**Addendum No. 1
to the Bidding Documents**

**Birnie Road Landfill Closure Project – Phase II
Town of Longmeadow
Longmeadow, Massachusetts**

Issued February 19, 2020

G-001

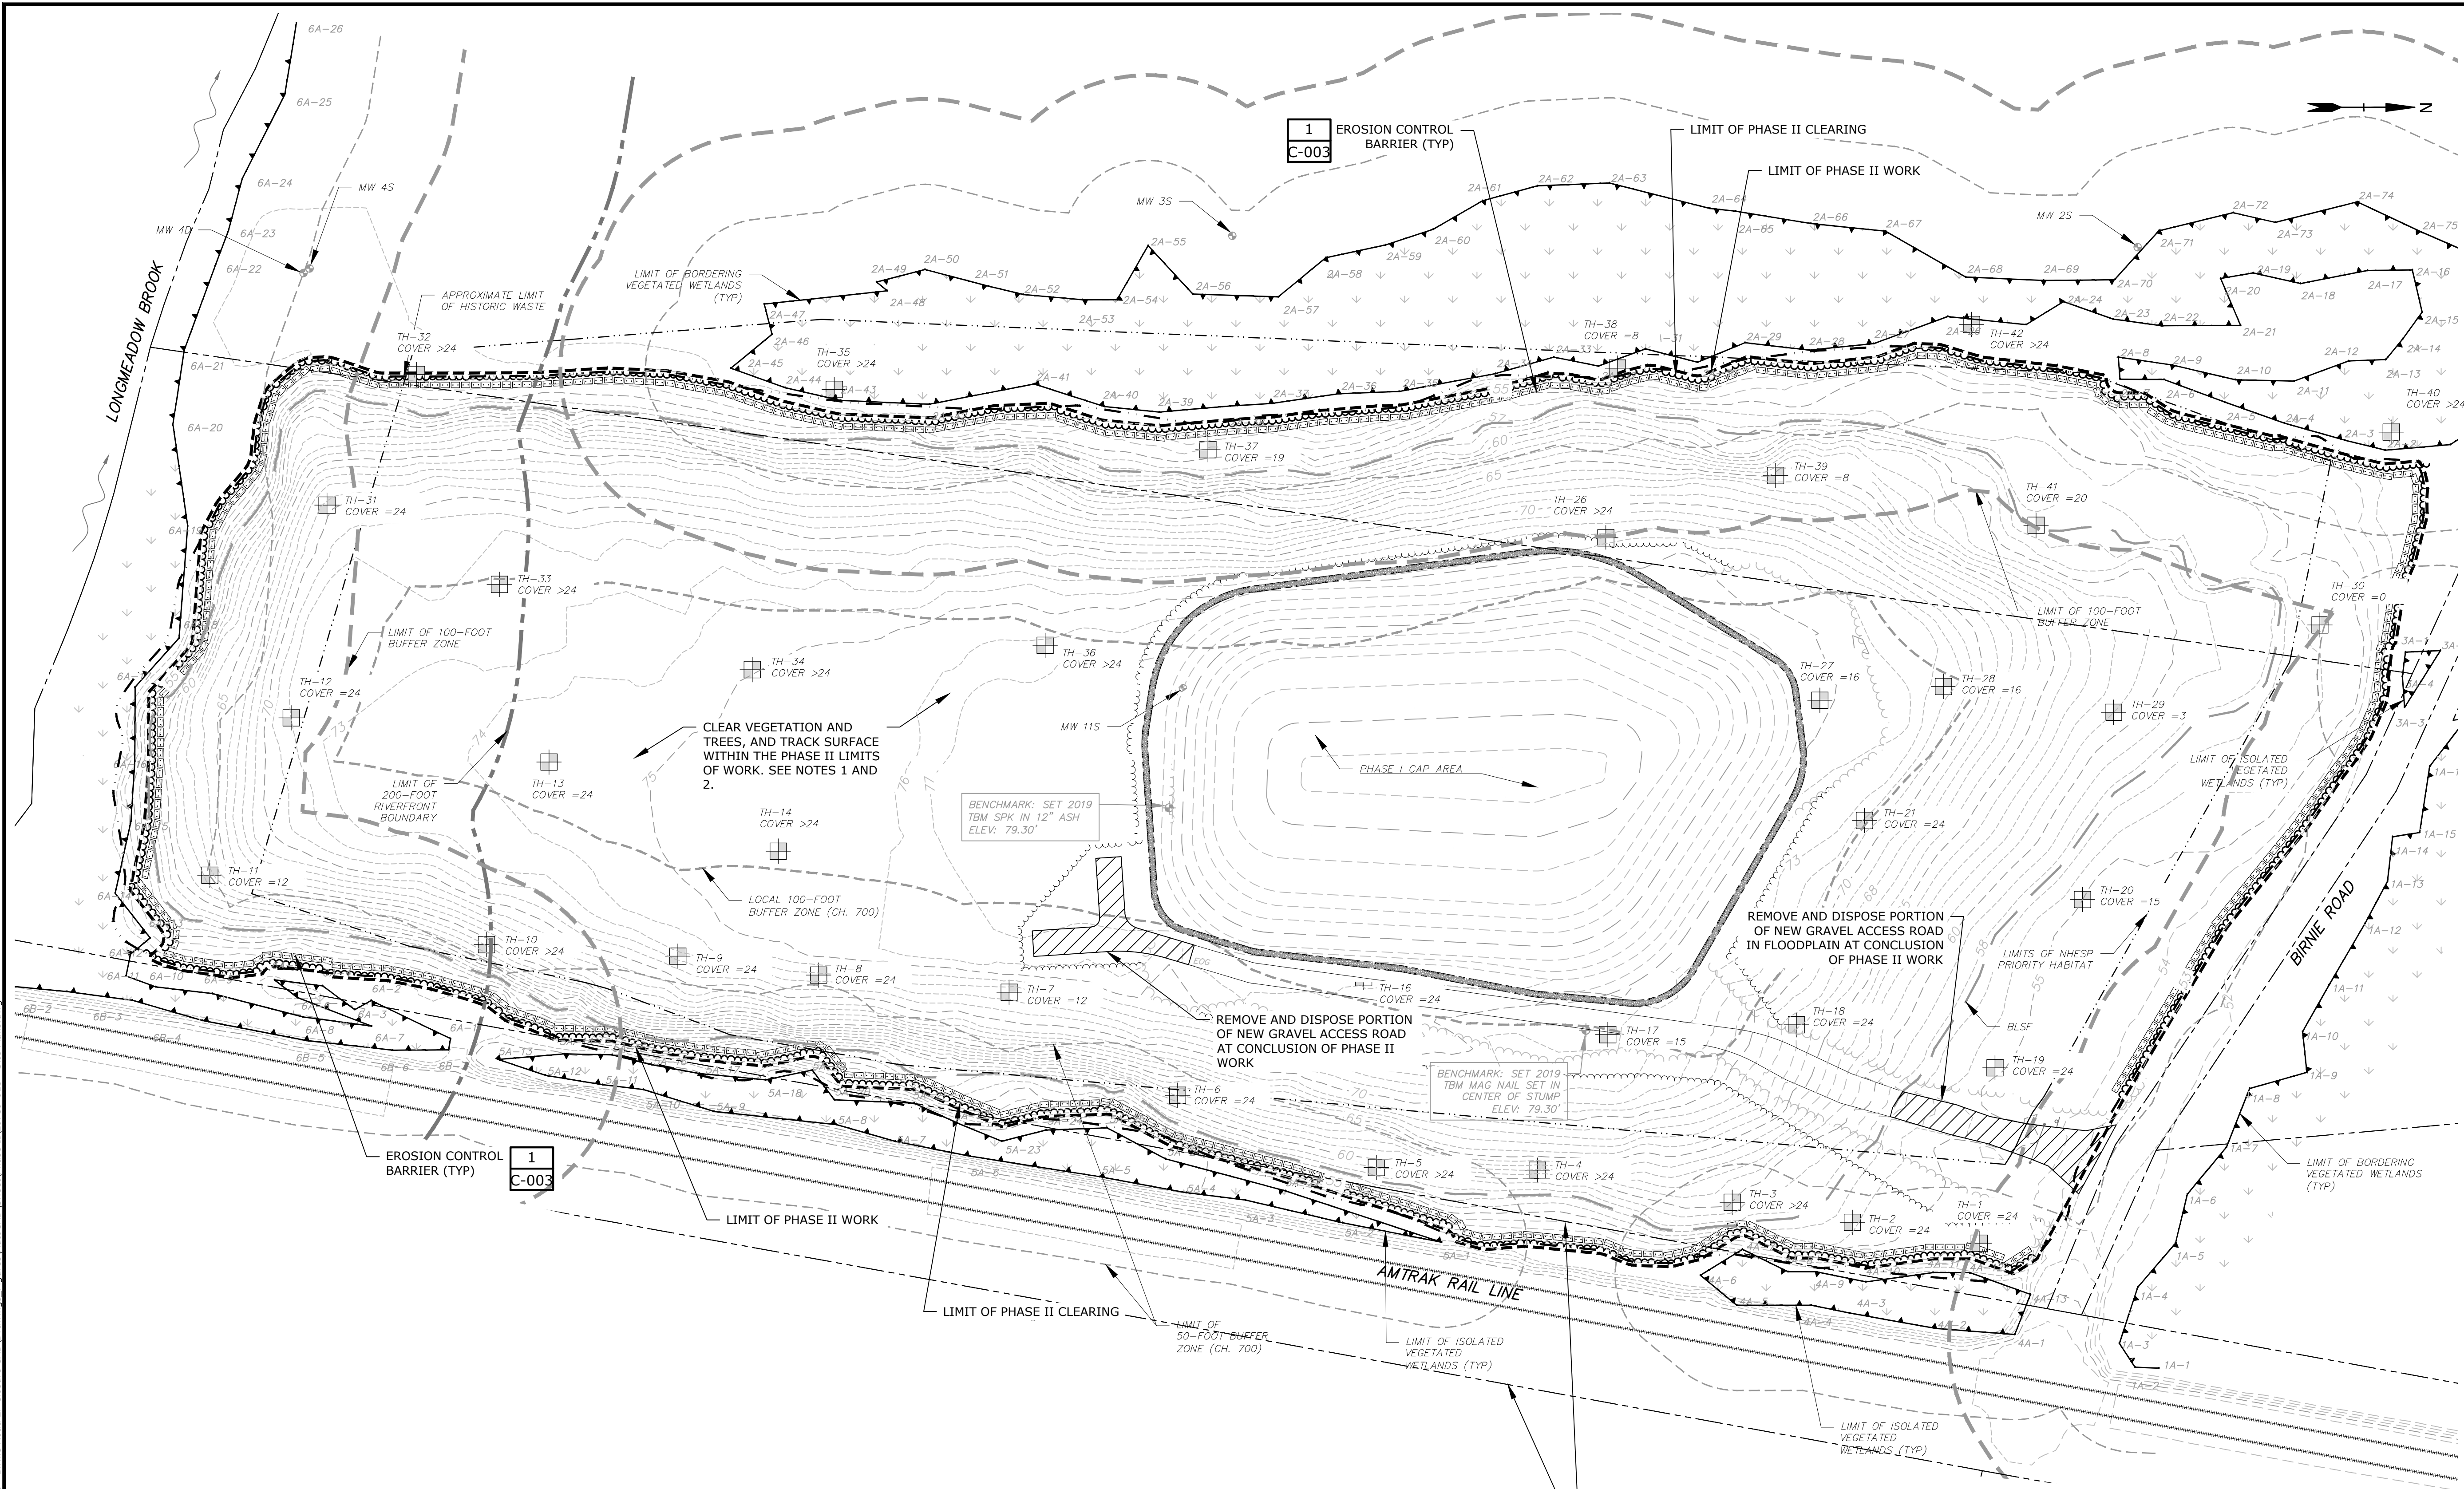
Drawing Changes**Item 1-6 Sheet G-001, General Notes, Legend, and Abbreviations Plan**

Property Line linetype has been added to the Legend on the plan sheet.

Add the revised Sheet G-001 to the Contract Documents and **Remove** the previous Sheet G-001.

SCALE: 1" = 50'
C-001

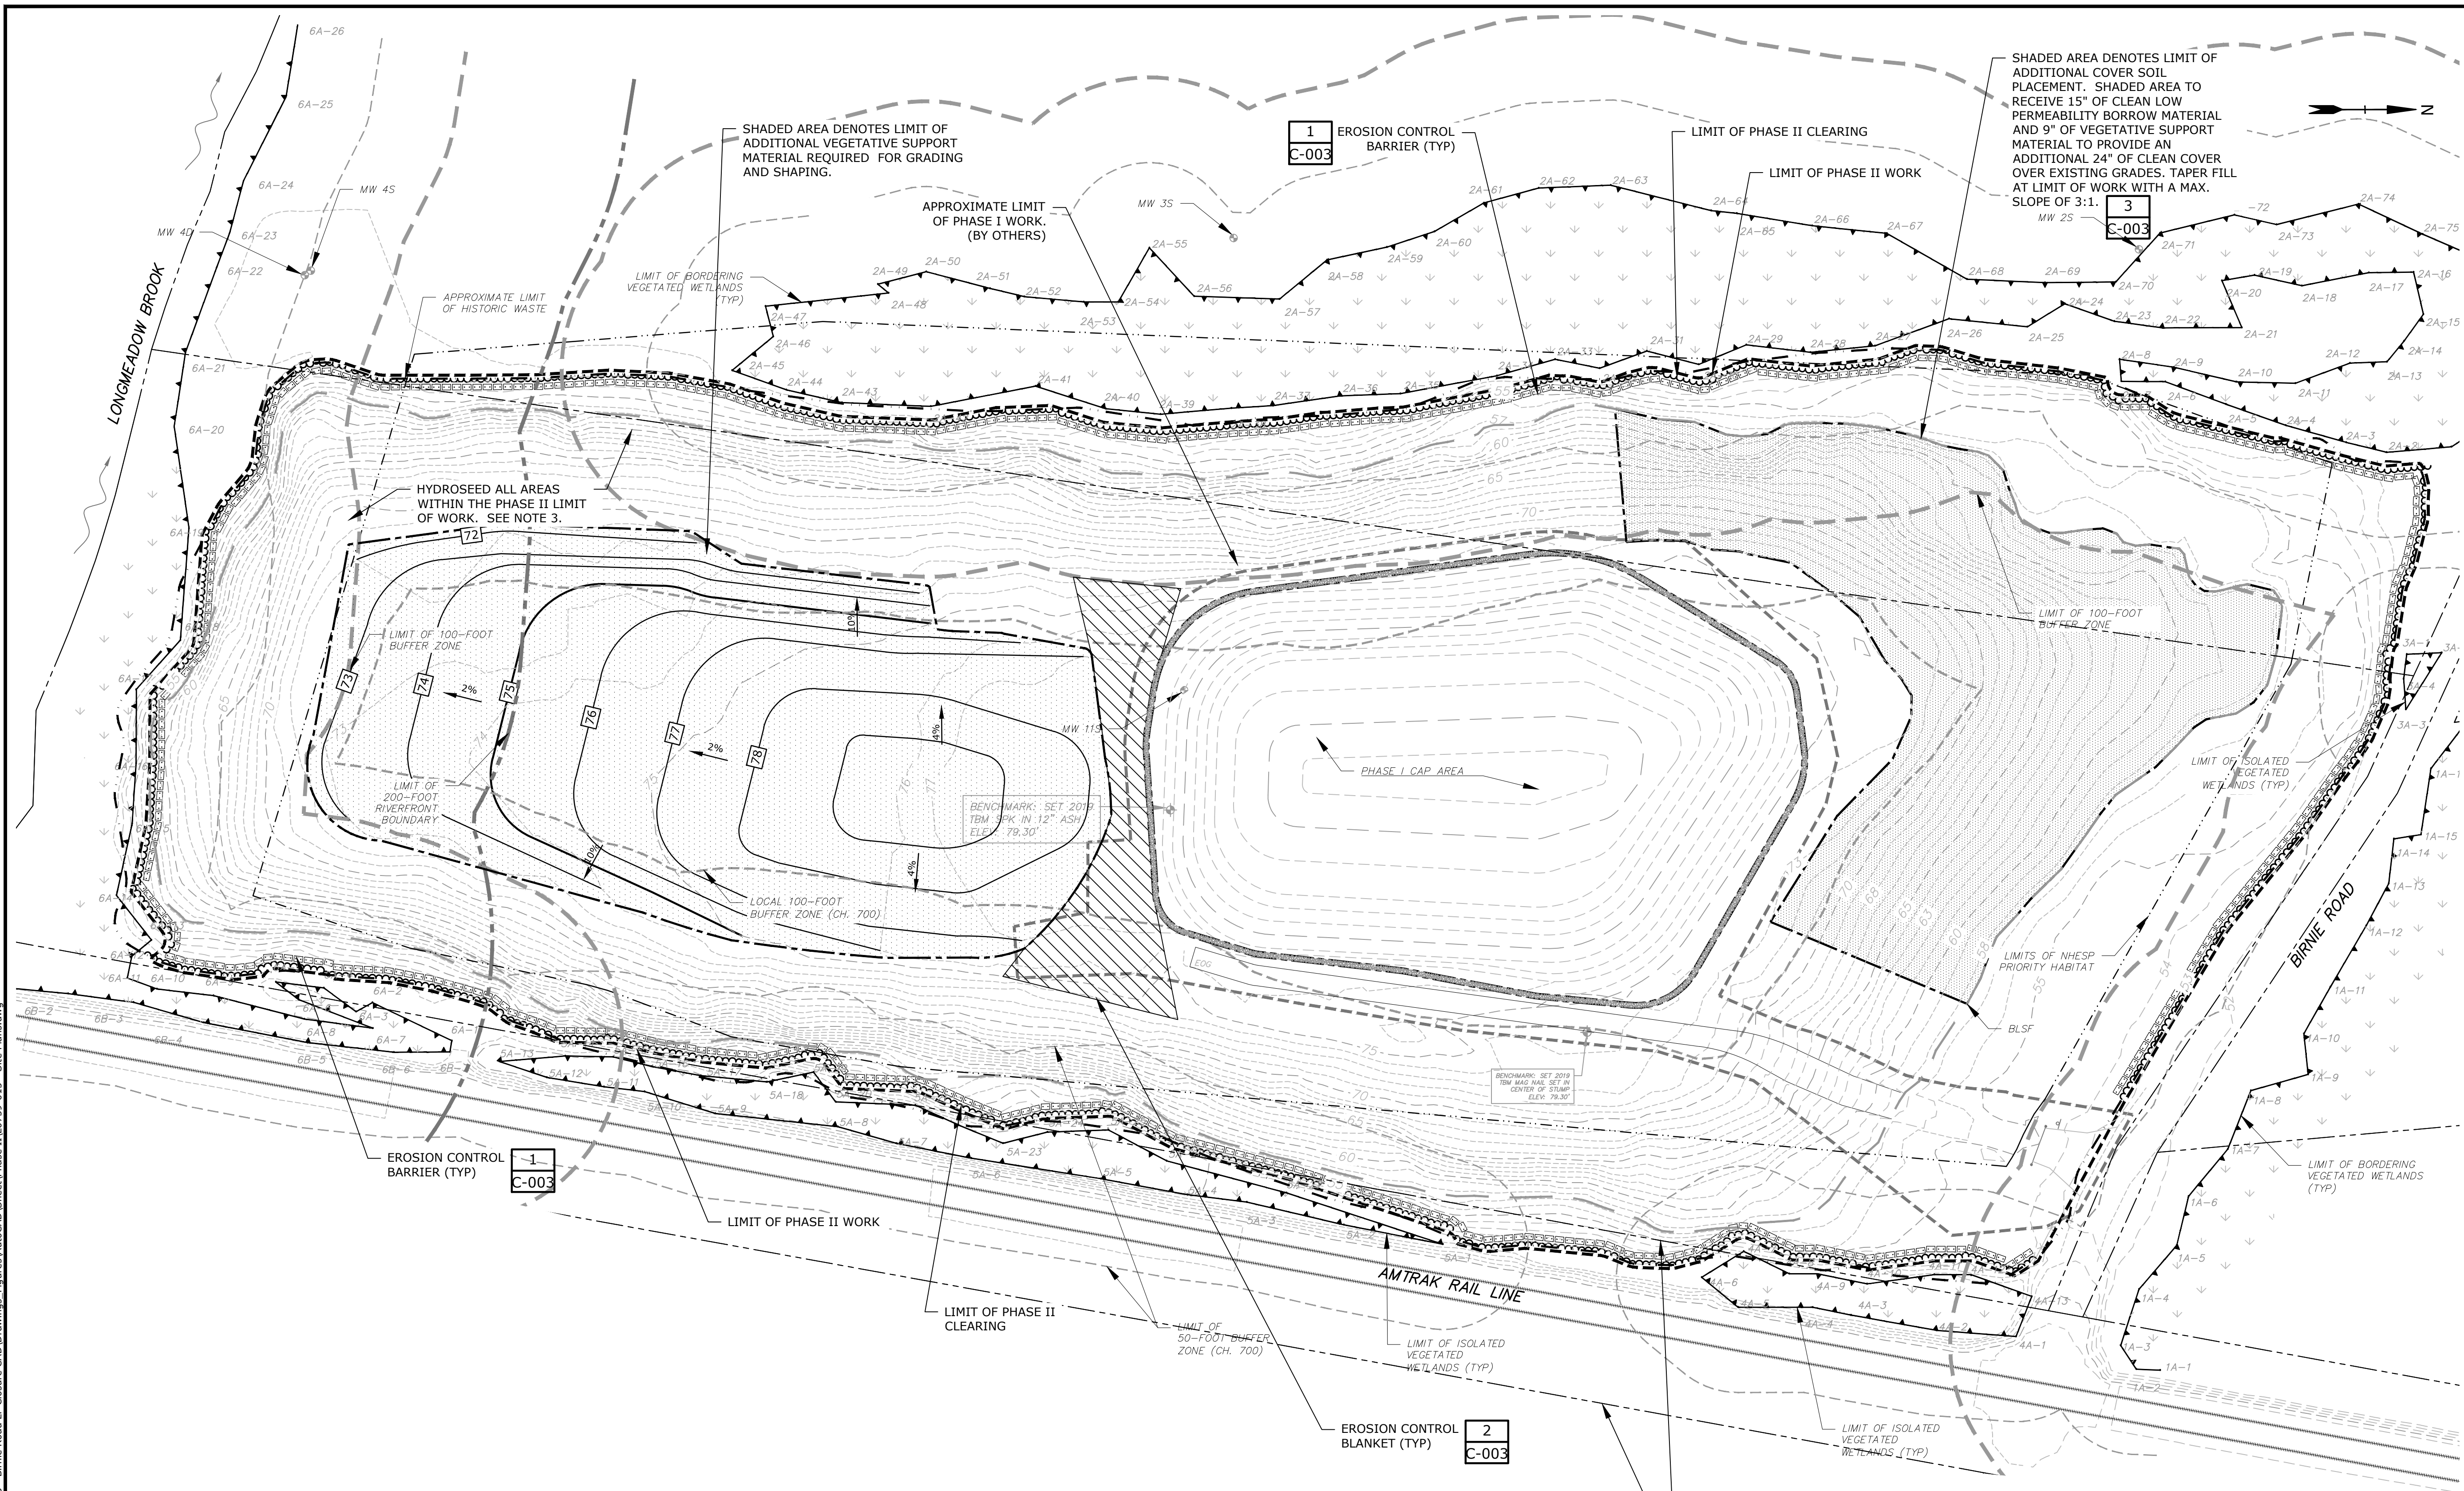
Item 1-7 Sheet C-001, Existing Conditions and Demolition Plan

Property Line information has been provided on the plan sheet.

3. Can woodchips be left on the site from stump grinding?

Refer to note 2 on sheet C-001.

Add the revised Sheet C-001 to the Contract Documents and **Remove** the previous Sheet C-001.
